TECHNICAL SERVICE BULLETIN

Bulletin Number: V-17-01
Model Years: 2017

SUBJECT: 2017 Victory Cross Country Tour - USB Audio Quality

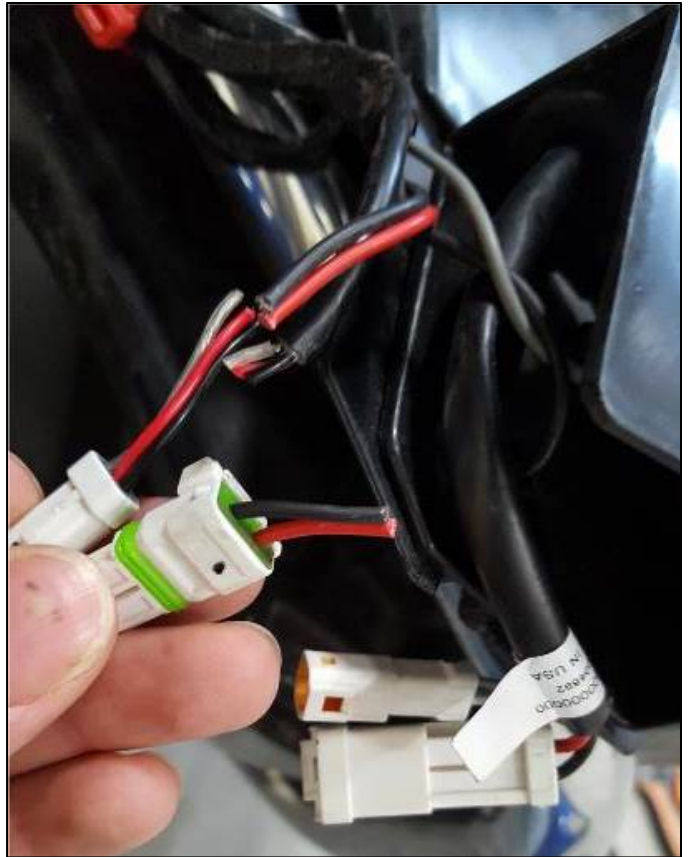
1. Open LH lower fairing door. Using a T25 driver, remove four highlighted fasteners.

2. Disconnect USB connectors.

3. Cut USB connectors off the chassis harness.

4. Place adhesive lined heat shrink tube over cut wires. heat tube until wires shrink around wires. While the heat shrink is still warm, crimp the end together with pliers to seal the wire ends.

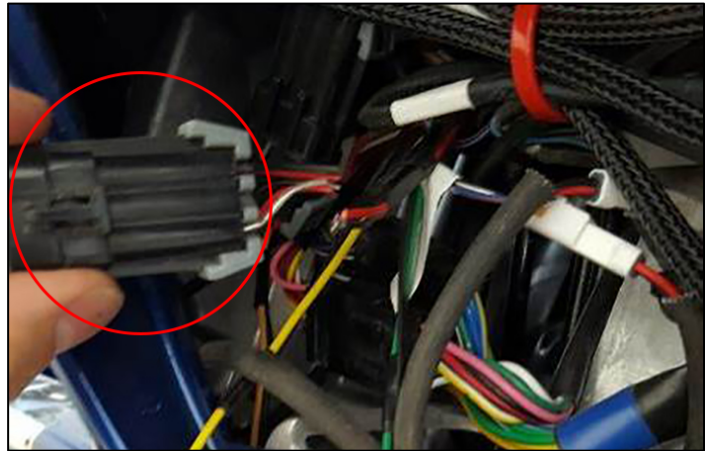
5. Use body tool PV-49955, pry one edge of bezel from fairing and pull forward to release clips. Remove headlight bezel.

6. Using a 5mm Allen Wrench, remove four highlighted fasteners retaining the headlight. Remove headlight.

7. Unplug chassis USB connector from fairing USB connector.

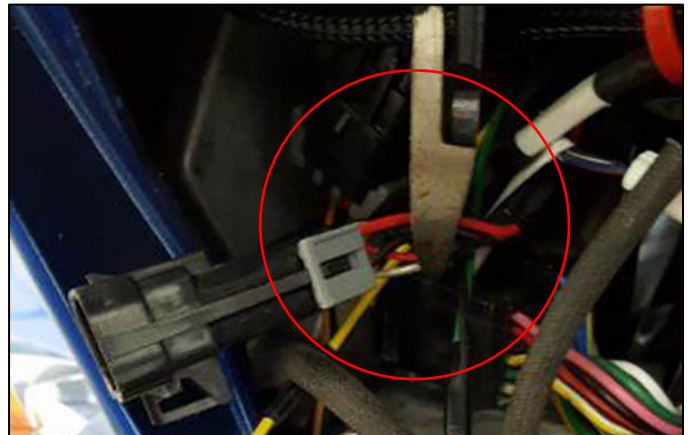
8. Cut male USB connector from chassis harness.

- Place adhesive lined heat shrink tube over cut wires. Heat tube until wires shrink around wires. While the heat shrink is still warm, crimp the end together with pliers to seal the wire ends.

- Connect USB extension harness to USB connector. Follow chassis harness routing and attach a new zip tie around the highway bar.

- Secure USB harness to chassis harness with a new zip tie connector.

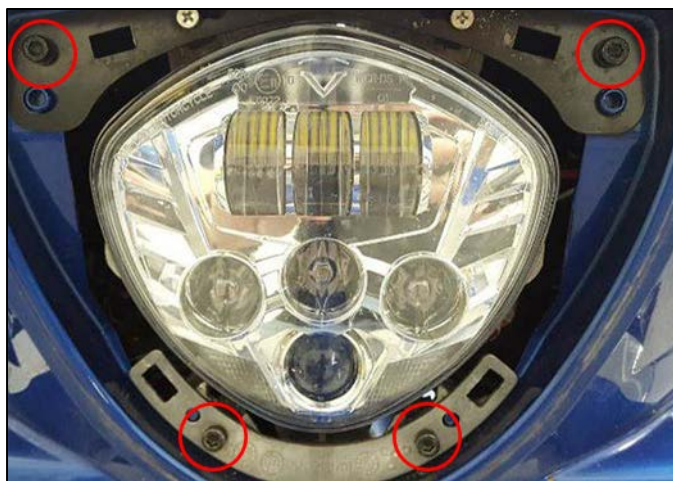
12. Secure USB harness to chassis harness with a new zip tie as close to chassis harness P-Clamp as possible.

13. Plug USB harness into fairing harness. Bundle the wires together and attach a new zip tie.
